<b>Location:</b>	<b>1431 Franklin Street</b>
<b>Assessor's Parcel Number:</b>	008 062100807
<b>Proposal:</b>	Major Conditional Use Permit and Regular Design Review to construct a 27-story (425-foot tall) 419,480 square feet office tower with a parking garage above grade.
<b>Applicant:</b>	TC II 1431 Franklin, LLC
<b>Phone Number:</b>	Kyle Winkler, Tidewater Capital, (510) 290-9901
<b>Case File Number:</b>	PLN20124
<b>Owner:</b>	TC II 1431 Franklin, LLC
<b>Planning Permits Required:</b>	Major Conditional Use Permit for large scale development; Regular Design Review
<b>General Plan:</b>	Central Business District
<b>Zoning:</b>	CBD-P Central Business District Pedestrian Retail Commercial Zone Height Area 7, no limit
<b>Environmental Determination:</b>	Determination Pending, Environmental analysis to be conducted prior to any discretionary action.
<b>Historic Status:</b>	Project site is located within an existing listed National Register historic resource, the Downtown Historic District Area of Primary Importance (API).

# LANDMARKS PRESERVATION ADVISORY BOARD

Case File: PLN20124  
Applicant: TC II 1431 Franklin, LLC  
Address: 1431 Franklin Street  
Zone: CBD-P  
Height Area: 7, No l

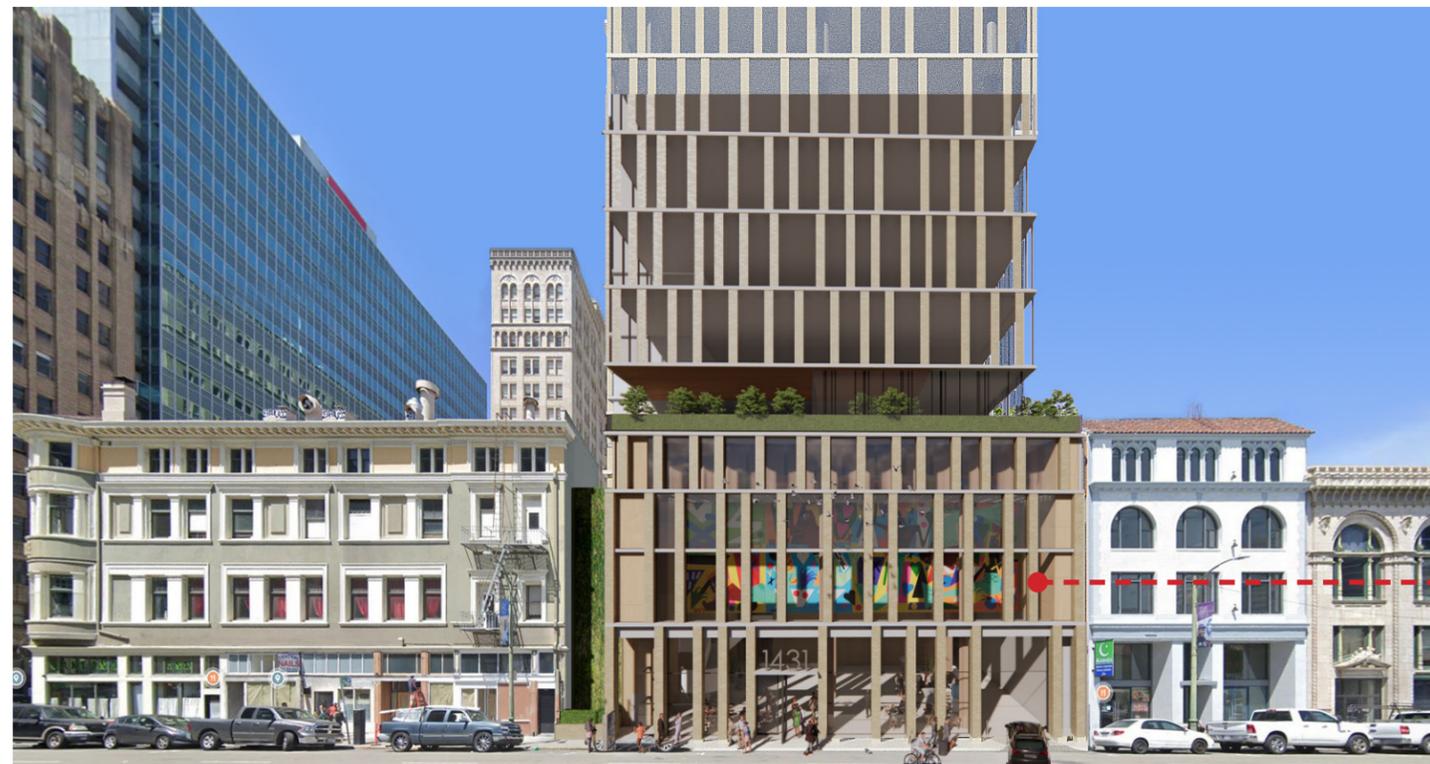
The proposal does not reflect the level and quality of visual interest of the API contributors or otherwise enhance the visual interest of the API. More details of composition, materials and projection are needed

The proposed design is not a historic replication of some of the older revivalist buildings in the area, nor is it a reinterpretation of some of the modern buildings. In general, the Historic district is most notable for its overall content. Across the road from the proposed project is not part of the historic district. The actual site itself is a parking lot and does not contribute to any historic district. The new proposal is like some of the modern Highrise buildings in the area, but instead of using only glass and metal at the base of the tower, the proposal uses finishes and materials in the style of the historic older buildings. The use of brick at the base of the building up to the 55-foot level is a deliberate design consideration to blend a modern building into the API. The proposed design has also brought across many of the proportions and rhythms of the historic buildings. The proposed project is not a literal interpretation of the historic buildings in the API, but unlike any of the other modern buildings in the entire downtown district of Oakland, the proposed design has been carefully crafted to keep many of the proportions and materials like the existing buildings. The datum lines have been brought across the façade unlike any other modern building in the area, and the use of brick at the base is unlike any other modern building in the area.

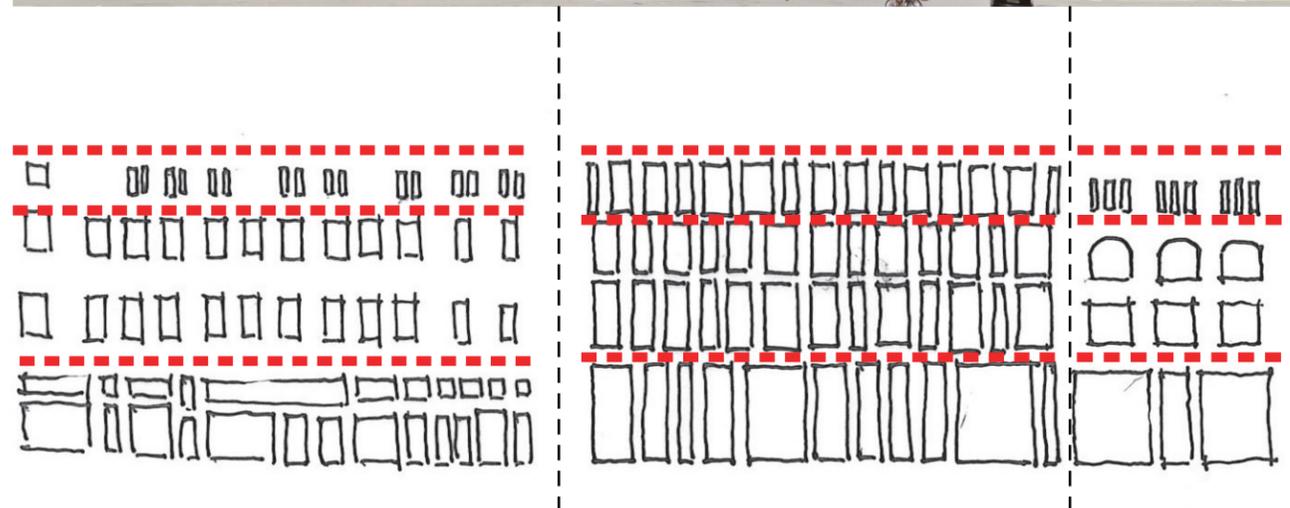
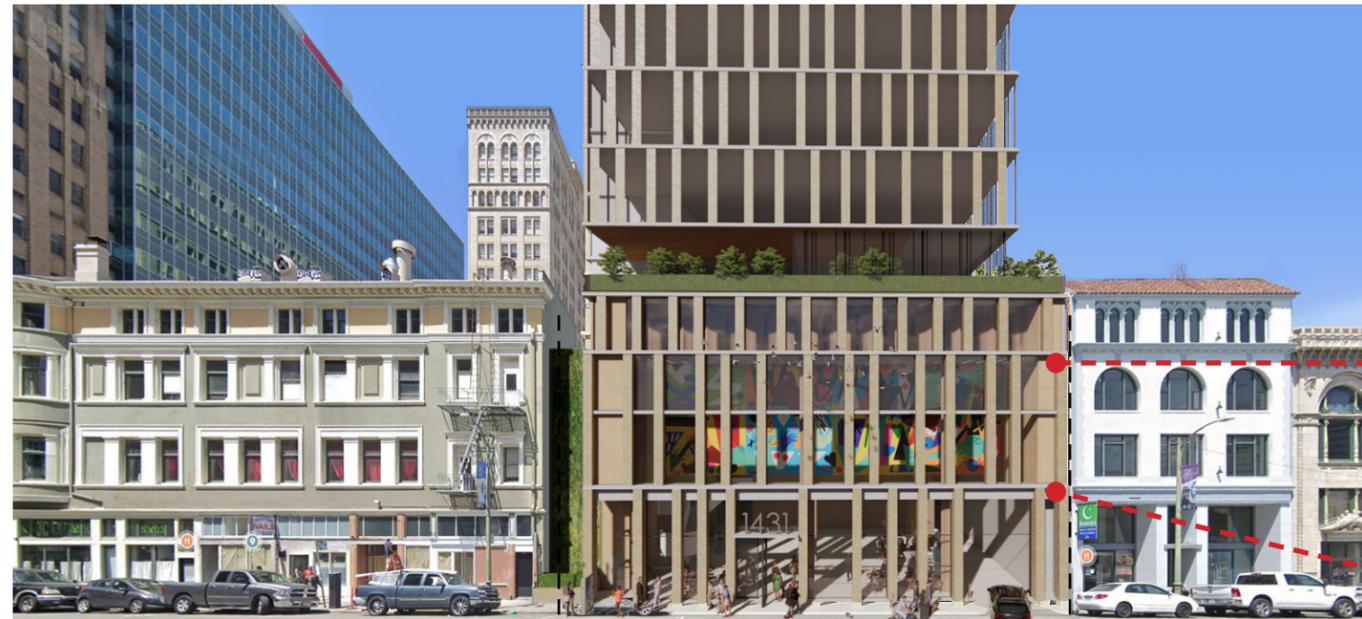
The proposal contains elements that relate to the character-defining height of the API, if any, through the use of a combination of upper story setbacks, window patterns, change of materials, prominent cornice lines, or other techniques. APIs with a character-defining height and their character-defining height level are designated on the zoning maps.

The base of the building has been redesigned to better reflect the widths and rhythm of the facades on the street, and entrances that reflect the patterns on the street. As previously noted, the revised design of the proposed building has a strong relationship to the adjacent buildings in terms of massing and, it's modern interpretation to the predominately classical horizontal layer that exists in the Historic district. The pattern of windows also mimics the window layout of the adjacent buildings in a modern way. In addition, the base of the proposed building will have a traditional brick base to pick up on the similar use of materials that are prevalent on the adjacent buildings in the Historic District. In addition, we have located key cornice lines to match the adjacent buildings. But it is worth noting that the cornice lines of the two adjacent buildings are not at the same height or size. With this in mind, we elected to split the difference and make for a compromise geometry that is intended to be visually as cohesive as possible. Most importantly the building matches the character-defining height of the API at the base with the building setting back above at the very prominent cornice line.
